PROJECT **WATERVUE**
643-651 HUNTER STREET NEWCASTLE NSW 2300

DRAWING No. DA011
DRAWING TITLE PLANNING - GFA
SCALE 1 : 250 @ A1
DATE 2023

DEVELOPMENT APPLICATION SHEET LIST		
DRAWING NO.	TITLE	REVISION
DA000	PLAN - LOCATION & DRAWING SCHEDULE	H
DA002	SITE ANALYSIS	B
DA003	PREDICT LOCATION PLAN	C
DA005	SITE PLAN	C
DA006	SHADOW DIAGRAMS	B
DA007	SHADOW DIAGRAMS	B
DA008	SHADOW DIAGRAMS	A
DA009	SOLAR ACCESS DIAGRAM	B
DA010	VENTILATION DIAGRAMS	B
DA011	PLANNING - GFA	G
DA012	UNIT AREA FOR CARPARKING GEN.	D
DA101	GROUND FLOOR	I
DA102	PARKING LEVEL 1	G
DA103	PARKING LEVEL 2	F
DA104	PARKING LEVEL 3	F
DA105	PLAN - PODIUM	H
DA106	PLAN - TYPICAL LOWER	G
DA107	PLAN - TYPICAL UPPER	F
DA111	PLAN - PENTHOUSES	C
DA112	ROOF	B
DA200	STREETSCAPE ELEVATIONS	B
DA201	ELEVATIONS - NORTH AND EAST	F
DA202	ELEVATIONS - SOUTH AND WEST	C
DA301	SECTIONS	C
DA321	RAMP SECTION CARPARK	C
DA401	PERSPECTIVE	B
DA402	PERSPECTIVE	B
DA403	PERSPECTIVE	B
DA409	MATERIALS + FINISHES	B
DA801	PODIUM LEVEL PRIVACY SCREENS	A
DA802	SIGNAGE DESIGN INTENT	A

DRAWING No. **DA202**
DRAWING TITLE **ELEVATIONS - SOUTH AND WEST**
SCALE **1 : 200 @ A1**
DATE **2022**

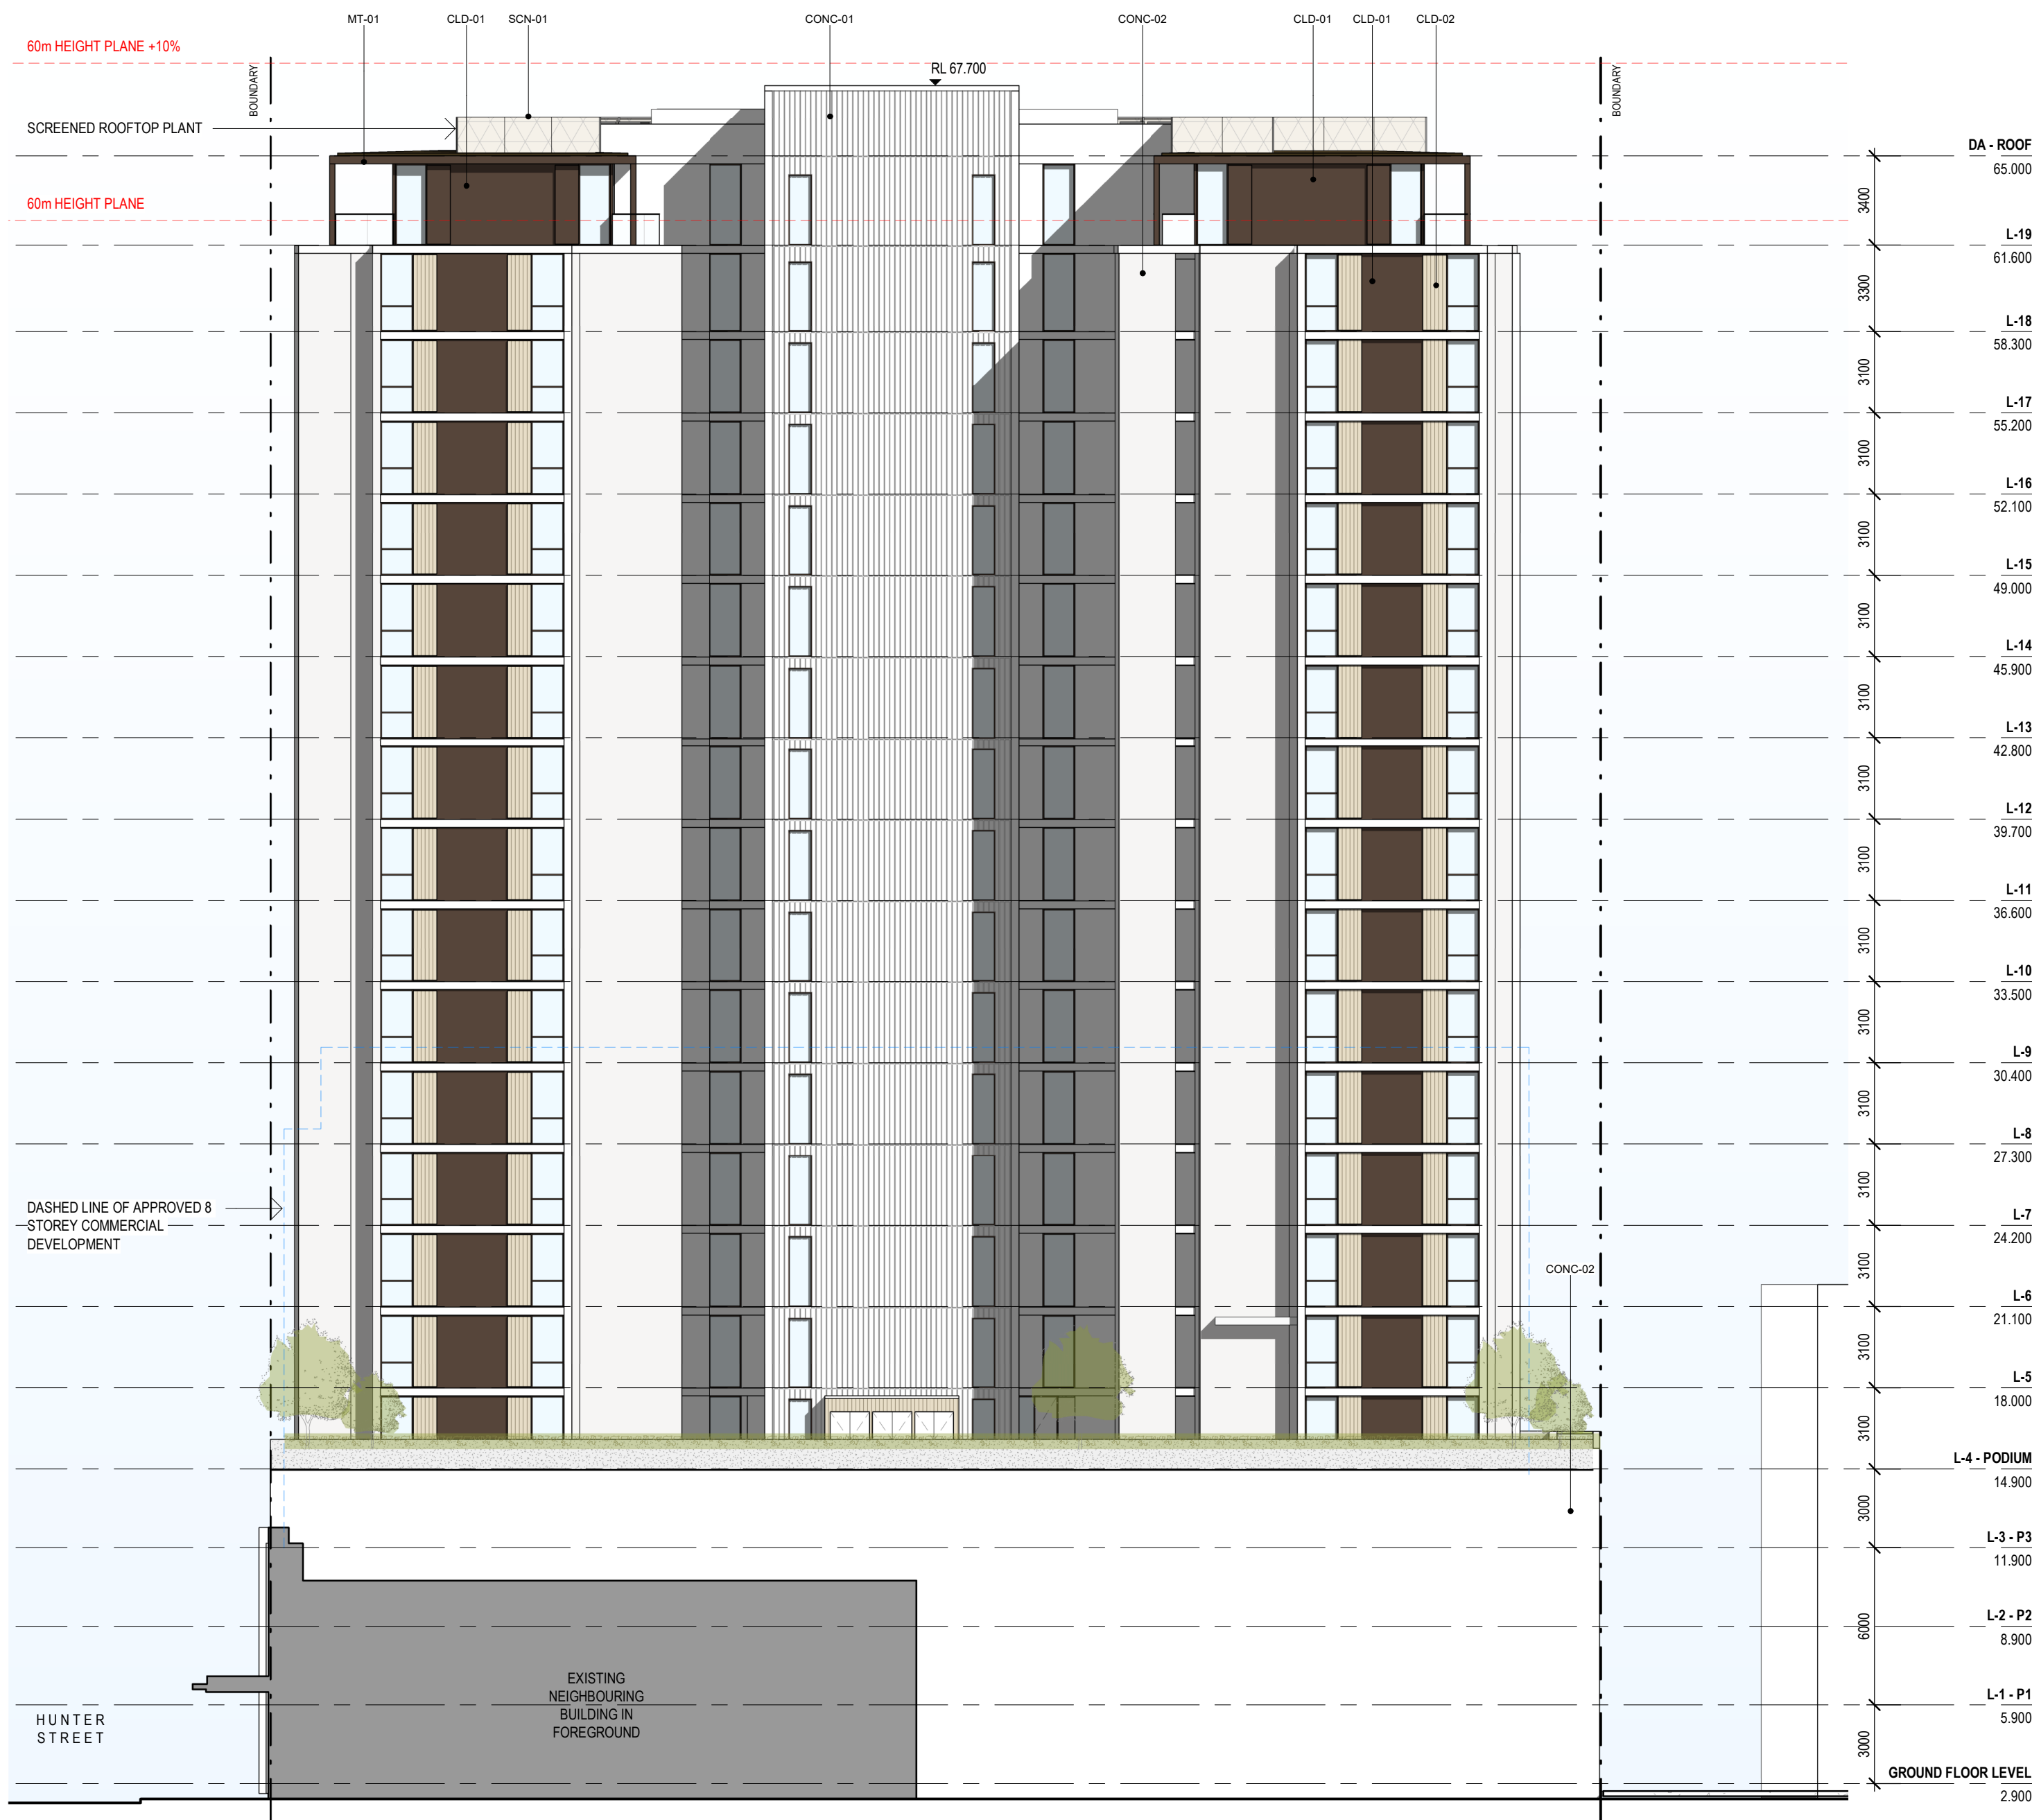
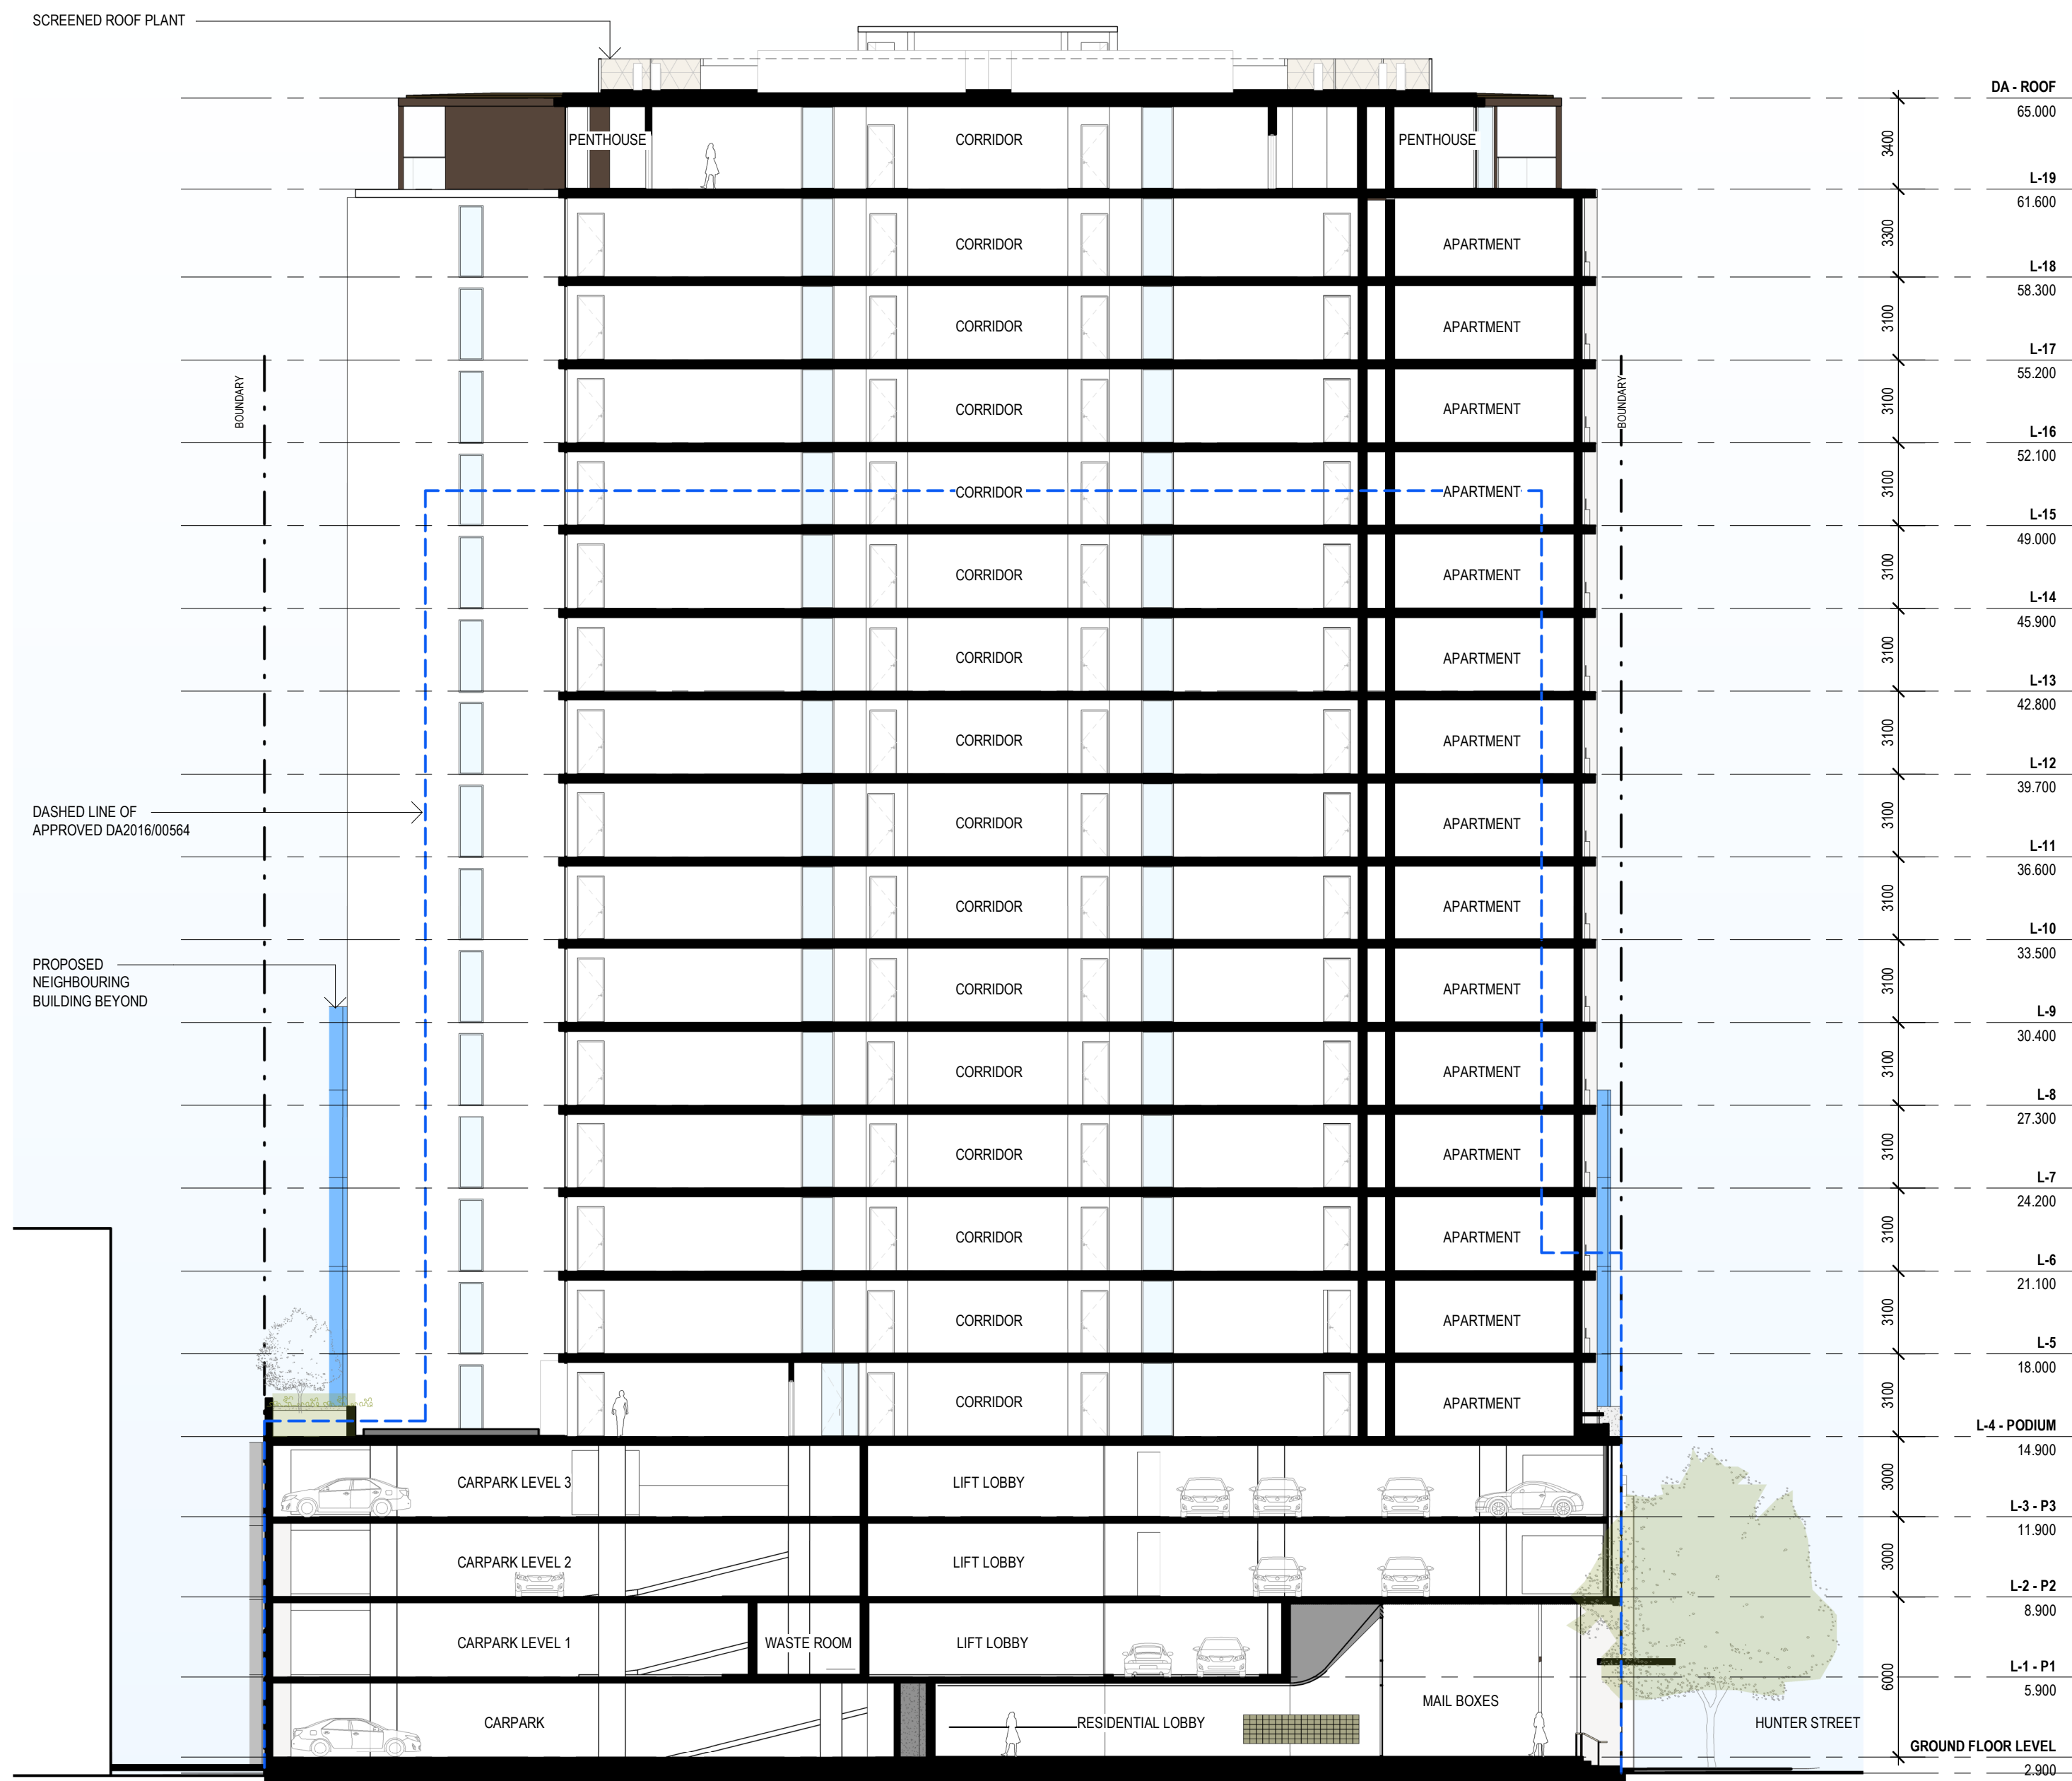
DA RFIS

- GROUND FLOOR CARPARKING LEVEL LOWERED BY 300MM
- DRIVEWAY GRADES UPDATED TO SUIT UPDATED PARKING LEVEL
- DOOR TO FIRE EGRESS CORRIDOR RELOCATED
- STEP ADDED TO FIRE EGRESS PATH TO SUIT UPDATED PARKING LEVEL
- STEPS AND PLATFORM ADDED TO MSB ROOM TO SUIT UPDATED PARKING LEVEL
- MAIL ROOM ADDED TO RESIDENTIAL LOBBY
- MAILBOXES RELOCATED INTO THE RESIDENTIAL LOBBY
- MOTORCYCLE SPACE DISTRIBUTION ACROSS L1, L2 AND L3 UPDATED (TOTAL REMAINS THE SAME)
- SECURE ENTRY ADDED AT BASE OF RESIDENTIAL CARPARK RAMP OF TO L1 RAMP LENGTH UPDATED TO SUIT UPDATED GROUND FLOOR PARKING LEVEL
- GARAGE ADDED TO L1 AND L2
- STORAGE CAGE ARRANGEMENT UPDATED
- LANDSCAPE COURTYARD ACCESS DOOR ADDED TO PODIUM LEVEL
- POOL PERGOLA SHOWN IN ELEVATION
